Application no 10/642,813
Application Dated August 19,2003
Reply to office action of October 25,2006

Amendments to the Drawings:

REMARKS/ARGUMENTS

Fig 3.A

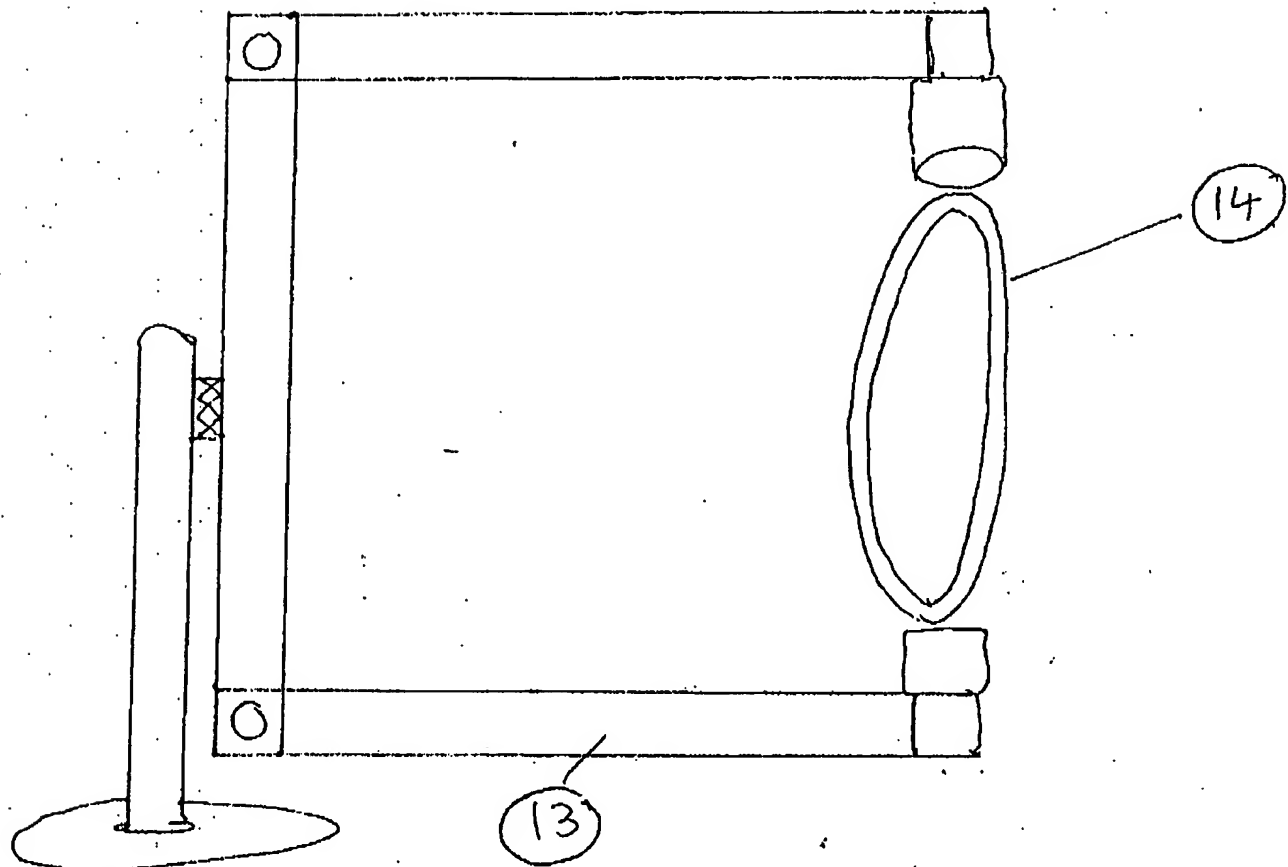
Legend "Prior art" has been added

Fig 3 A is amended as desired

Prior Art (added)
